SERVICE BULLETIN

APPLICABILITY: 2012-2013MY Impreza 2.0 Models
 2013MY XV Crosstrek

NUMBER: 12-221-17

SUBJECT: Body Creak Sound from Right Upper Corner of Rear Gate Opening

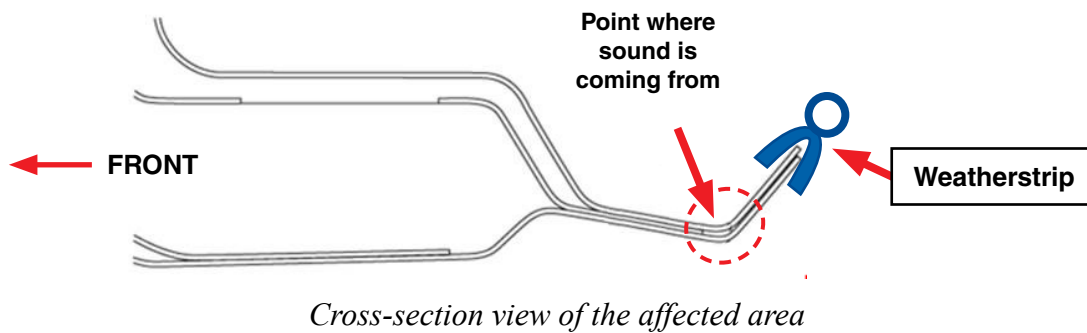
This bulletin outlines a procedure for addressing customer concerns of a creaking sound isolated to the upper right corner of the rear gate area on the models listed above. Over time, repeated twisting motions of the vehicle body may cause the overlapping layers of sheet metal in the affected area shown in the images below to come in contact and generate a creaking-type sound.

A production change was made November 20, 2012, after VIN **D*819916** to the body structure increasing the clearance between the layers of steel.

- Using a set of chassis ears, confirm the sound is coming from the referenced area.
- **CAREFULLY** remove the inner trim panel and rear gate weatherstrip for access.

- Separate the layers of sheet metal as shown below.

- After separating the layers of sheet metal, SPARINGLY apply a SMALL amount of the Endura penetrating grease into any newly-created gap using the aerosol applicator tube to be more precise and eliminate any overspray.
